DEPARTMENT OF THE ARMY
CHARLESTON DISTRICT, CORPS OF ENGINEERS
69-A Hagood Avenue
CHARLESTON, SOUTH CAROLINA 29403-5107

We are in receipt of your November 1, 2016 response to the Corps' October 17, 2016 request for additional information letter; however, additional information is required before consideration can be given by the concerned agencies and other interested parties. The following information must be provided to this office in order to complete your application:

RE: Interstate 77 Widening and Rehabilitation (from MM 15 – MM 27)
USACE SAC-2015-00155. SCDOT PIN P027002

APPLICATION BY SCDOT
PROJECT ID P027002: I-77 WIDENING
AND REHABILITATION (MM15-MM27)
RICHLAND COUNTY, SC
DATE: 8/2016
SHEET: 11 OF 31
REVISION DATE: 11/18/16

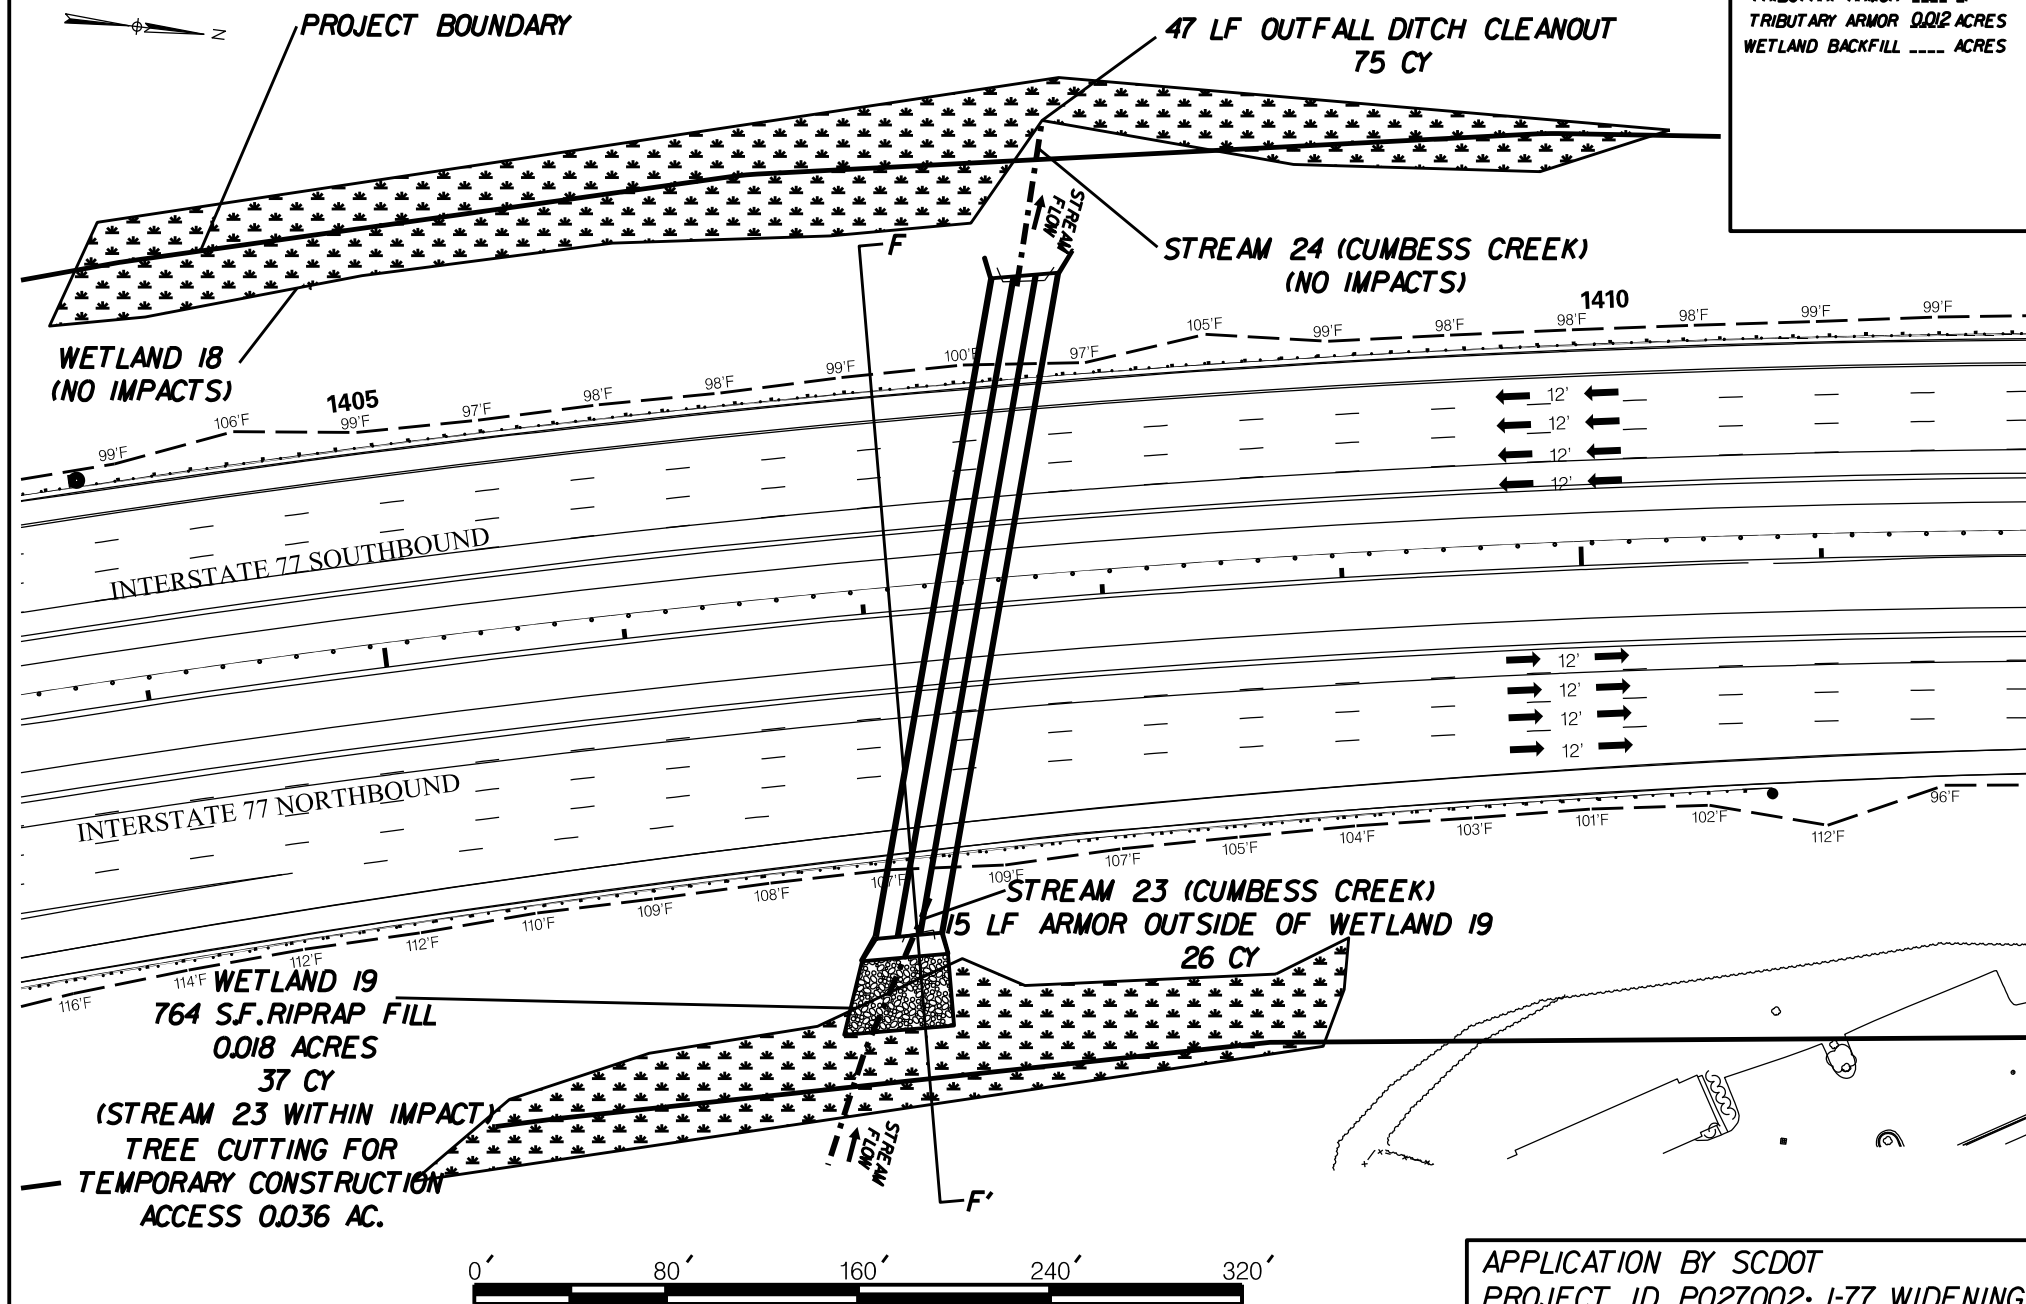
1. *You requested that safety zone clearing locations within forested wetlands and/or scrub shrub wetlands be depicted on revised site plans as well as any temporary clearing for construction access.*

Temporary construction access tree cutting will be needed for placement of riprap at some of the pipe/culvert ends and the Outfall Ditch Cleanouts. Revised sheets are enclosed pursuant to our conversation with the areas quantified on the plans. In summary, tree cutting will be required as described in the following table.

Station/Sheet	Wetland/Stream	Area
1407+20/9	W19/S23	1583 SF/0.036 AC
1423+15/11	W20/S25	768 SF/0.018 AC
1459+60/12	W21/--	1687 SF/0.039 AC
1469+60/13	W22/S26	1487 SF/0.034 AC
Total	--	5525 SF/0.127 AC

(STREAM 25 WITHIN IMPACT)
TREE CUTTING FOR TEMPORARY
CONSTRUCTION ACCESS 0.018 AC.

I-77 Project Limits
Figure 2
April 2015

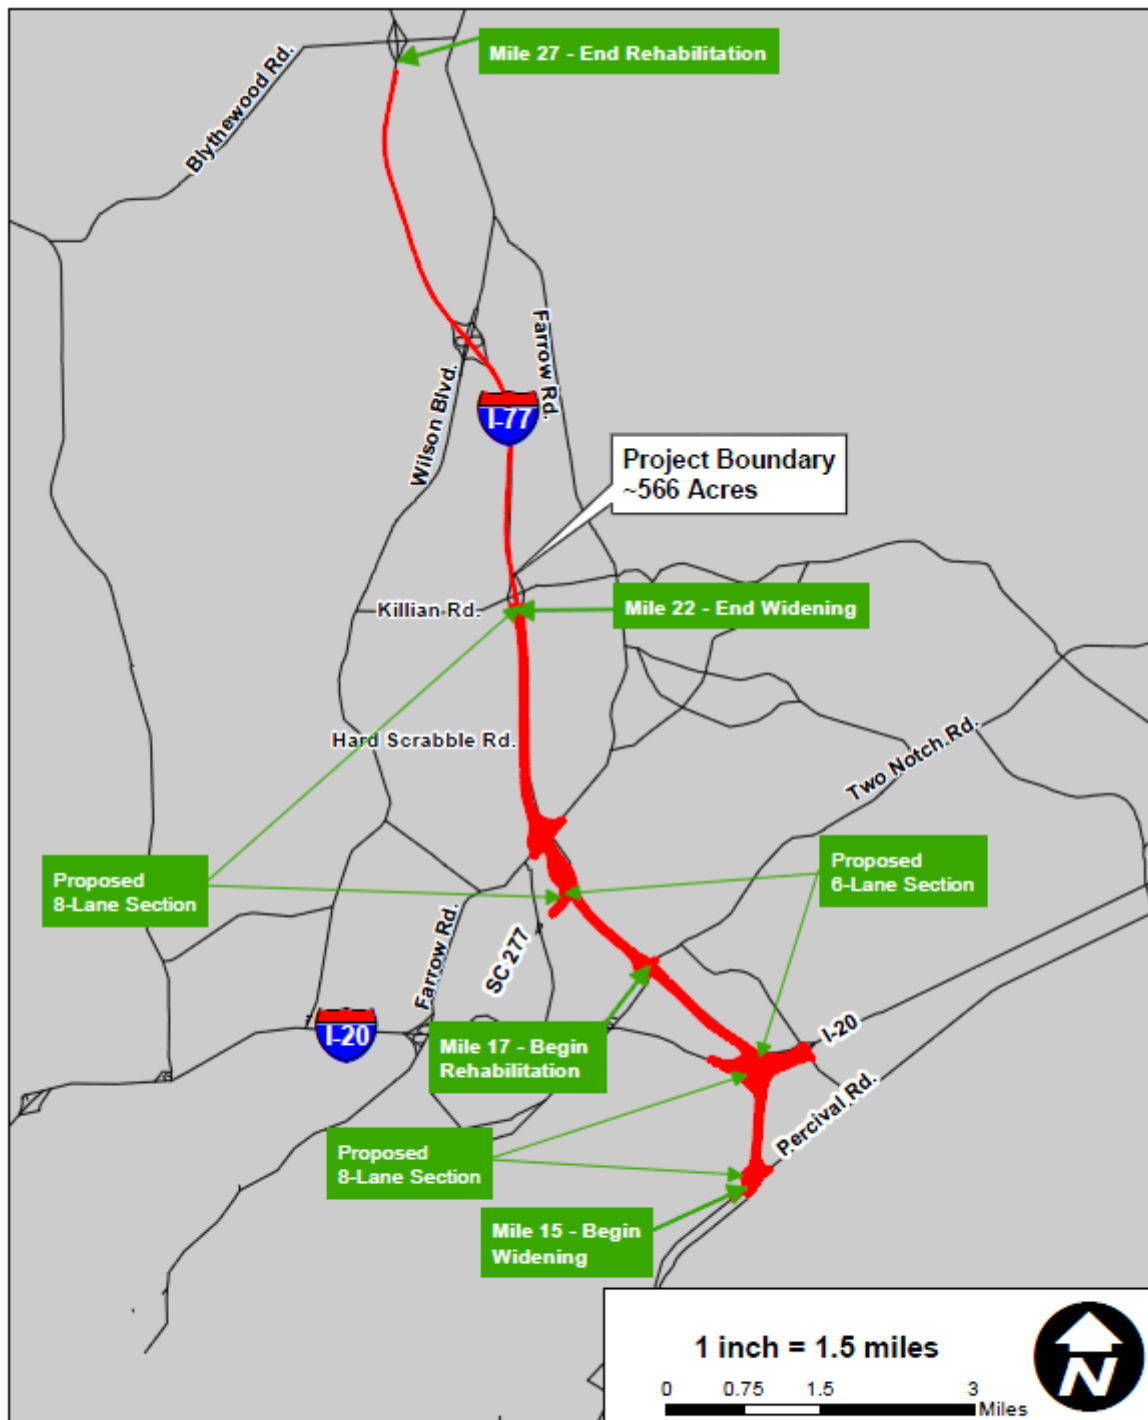
The USACE has requested that we clarify the study area examined for the I-77 widening and rehab project in Richland County, South Carolina. The cultural resources report submitted for this project did not adequately describe the study area associated with the rehabilitation portion of the project. As indicated in the project description, the proposed project would include the widening of Interstate 77 from Percival Road to Killian Road and the rehabilitation of southbound I-77 from Killian Road to Mile Point 27 in Blythewood (see map below). All rehabilitation activities would occur within previously disturbed portions of Interstate 77; therefore no archaeological or historic architectural investigations were conducted. As described in the report and our coordination letter, the no historic properties would be affected by the proposed undertaking.

Hey Chad,
Thanks for sending this along. It looks good to me – our office concurs that no historic properties will be affected.
All the best,
Adrienne
